TEMPORARY REVISION

PSM: 1-64-2W **AIRCRAFT: DHC-6** **SERIES: 400**

PUBLICATION: WIRING MANUAL **TEMP. REVISION NO.: TR28-2**

Insert in 28-20-00 before page 1
FUEL CONTROL SYSTEM

FUEL CONTROL SYSTEM

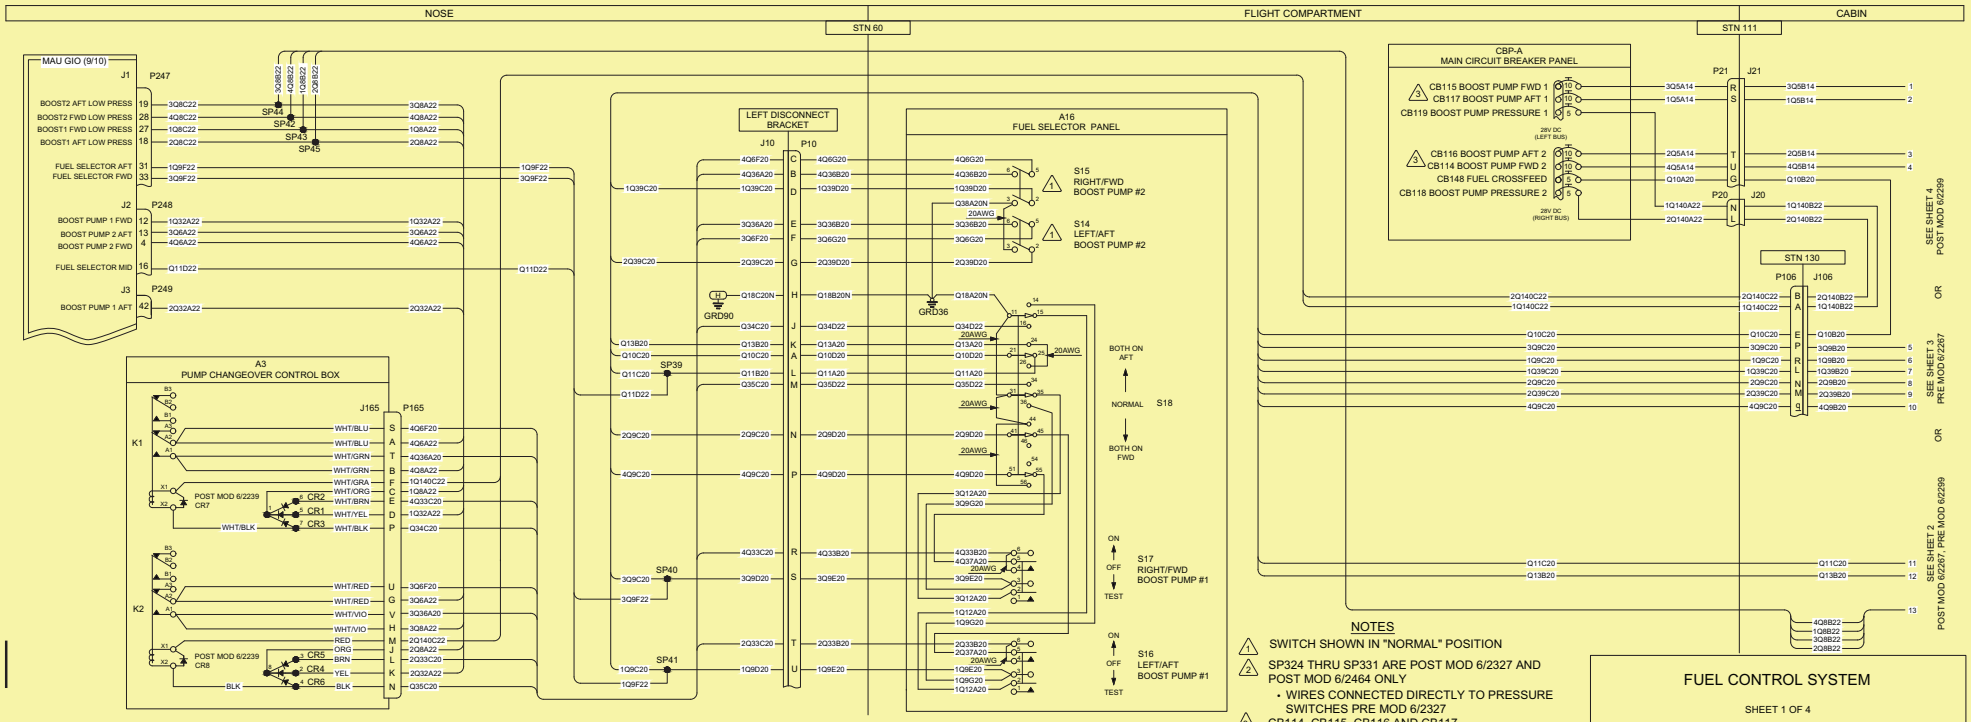
To introduce Mod 6/2464, Fuel Pressure Switch Replacement.

In Chapter 28, ignore existing Section 28-20-00 and insert revised Section, as shown on Pages 3 to 10 of this Temporary Revision.

1. SWITCH SHOWN IN "NORMAL" POSITION
2. SP324 THRU SP331 ARE POST MOD 6/2327 AND POST MOD 6/2464 ONLY
   - WIRES CONNECTED DIRECTLY TO PRESSURE SWITCHES PRE MOD 6/2327
3. CB114, CB115, CB116 AND CB117 10 AMPS POST MOD 6/2299; 15 AMPS PRE MOD 6/2299
